MODIFICATION REPORT

Avonlie Solar Farm SSD 9031

October 2020

Project Number: 17-439

Avonlie SF Subdivision

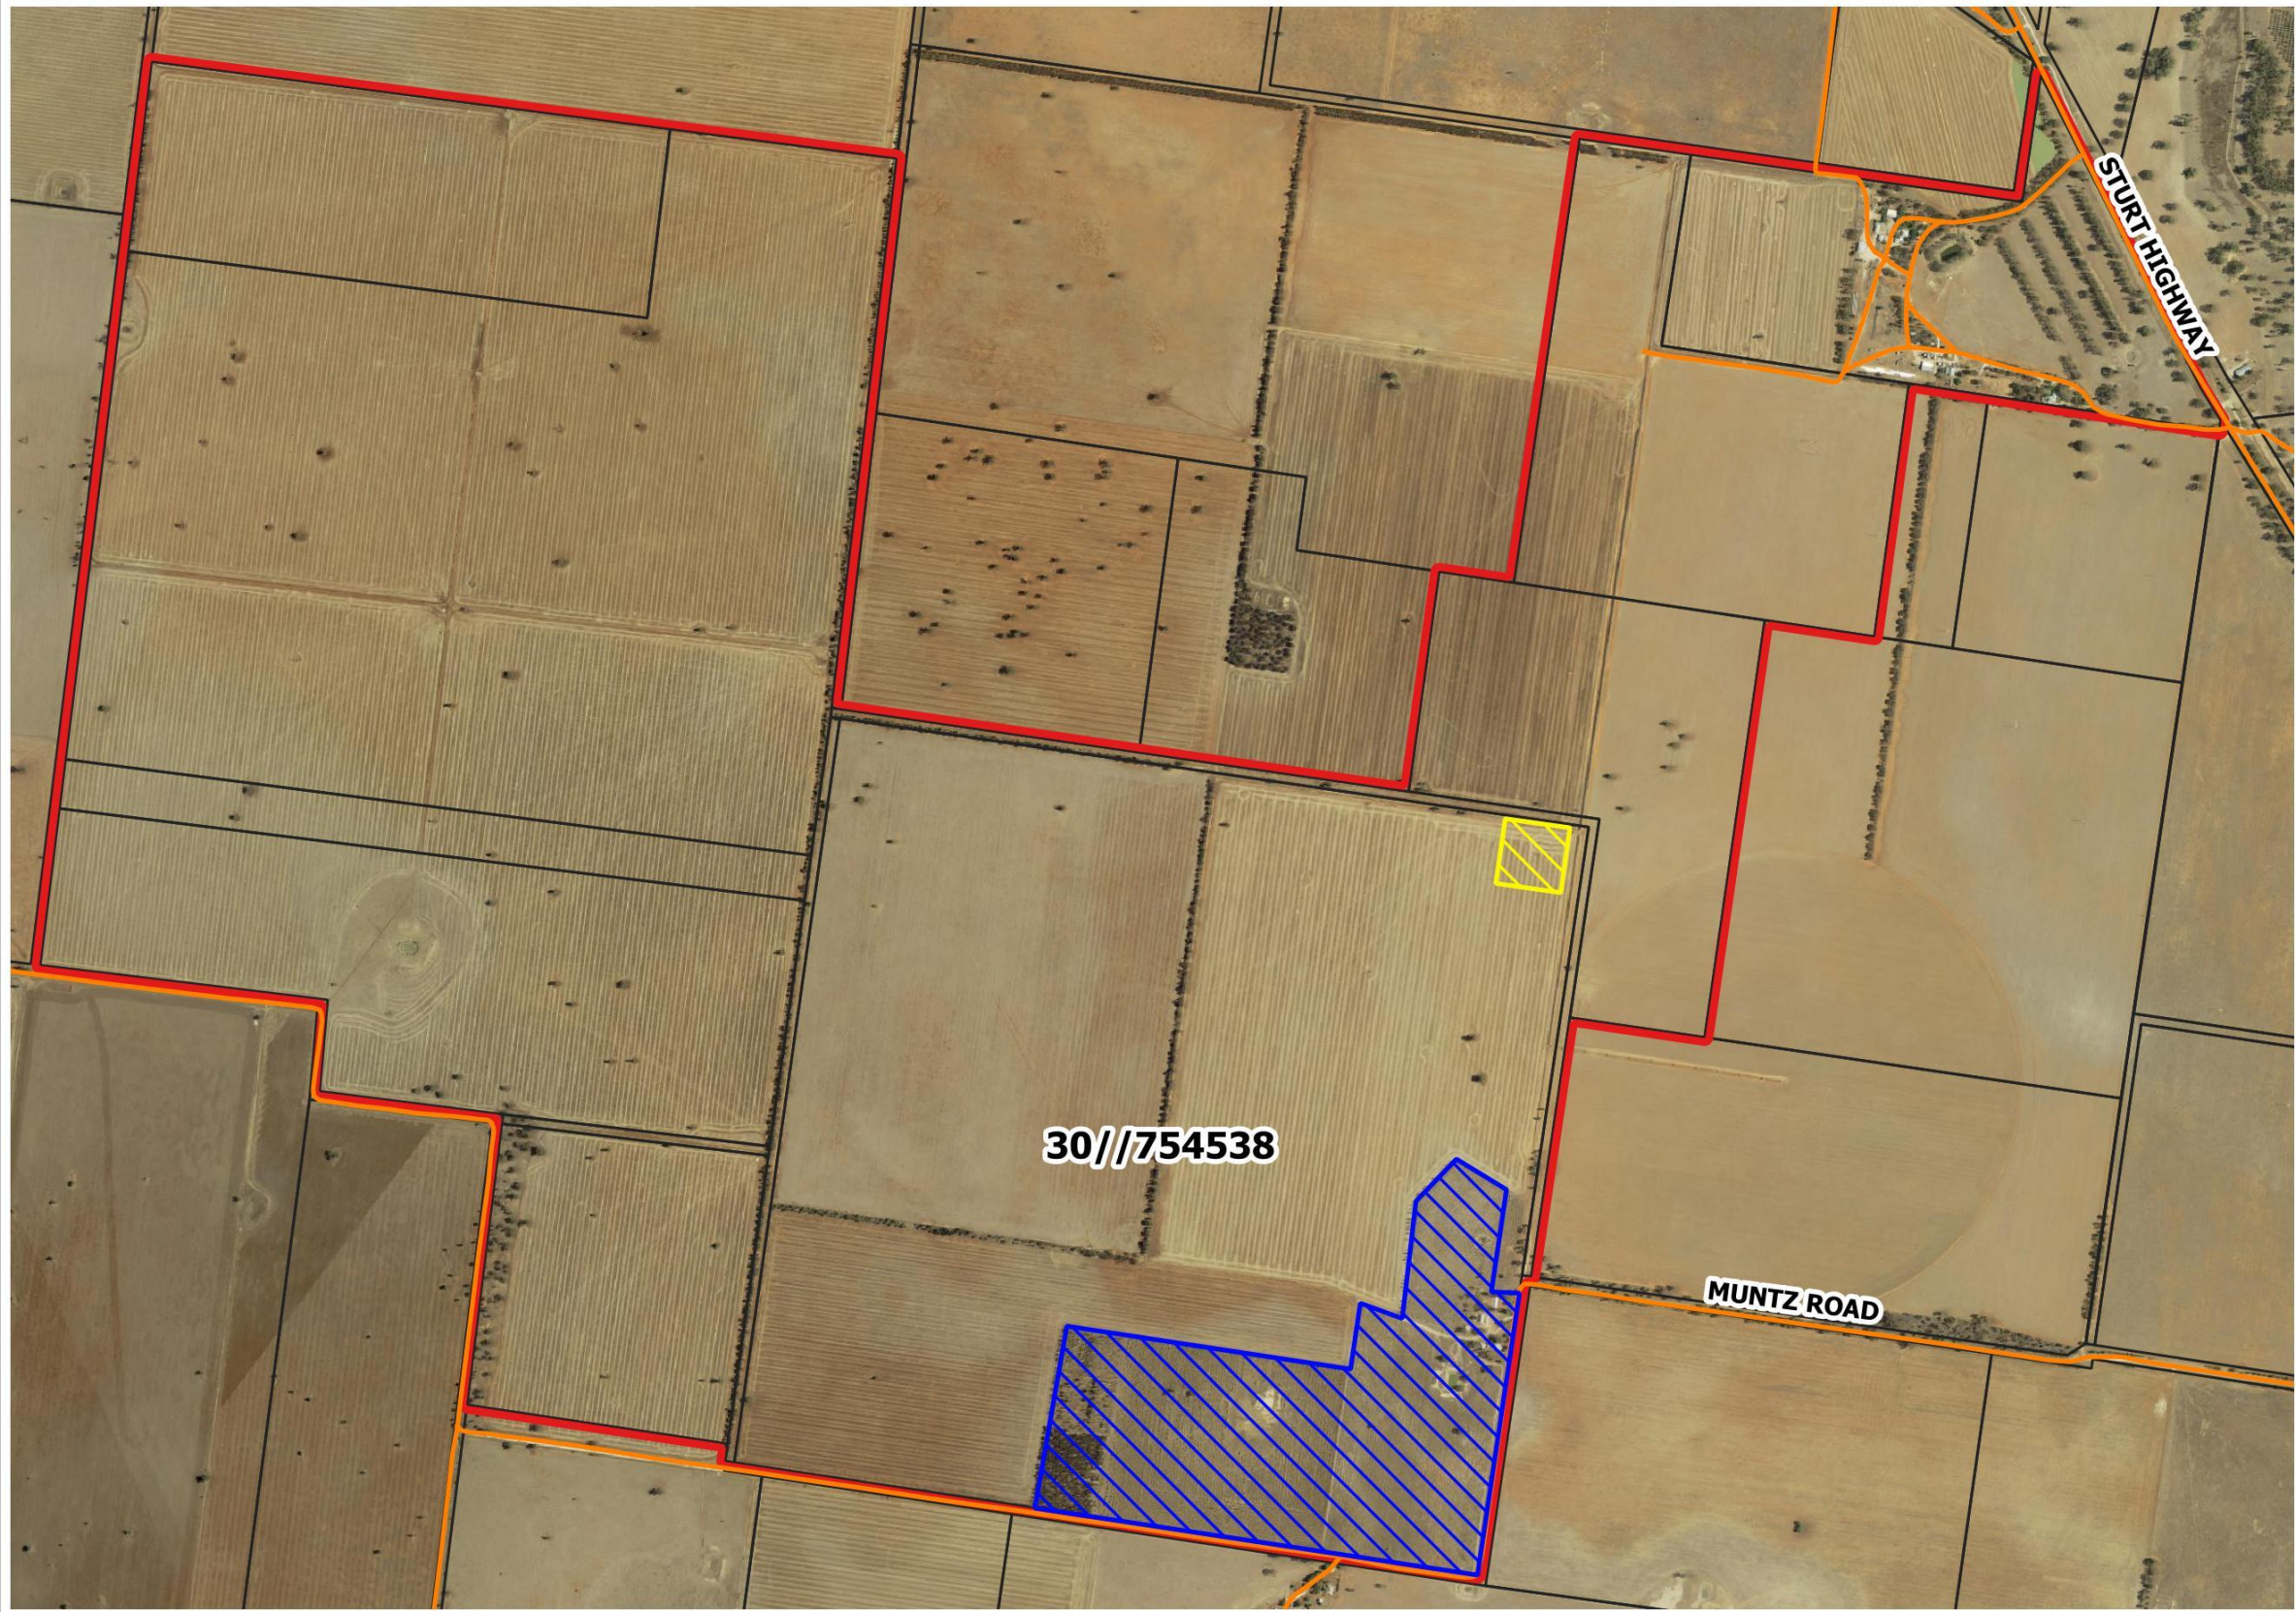
A minor adjustment to the substation position and area to be transferred to TransGrid has also been included in this modification report. The proponent has worked closely with TransGrid, following development approval, to establish a workable detailed design of the substation and vehicle access. During this consultation it was confirmed the substation would need to be slightly repositioned to enable over dimensional vehicles to safely access the substation. TransGrid also required an Asset Protection Zone (APZ) of 20m to be added to the substation fenced perimeter and this area included in the substation subdivision land to be transferred to TransGrid. The revised subdivision plan is provide at Appendix A.
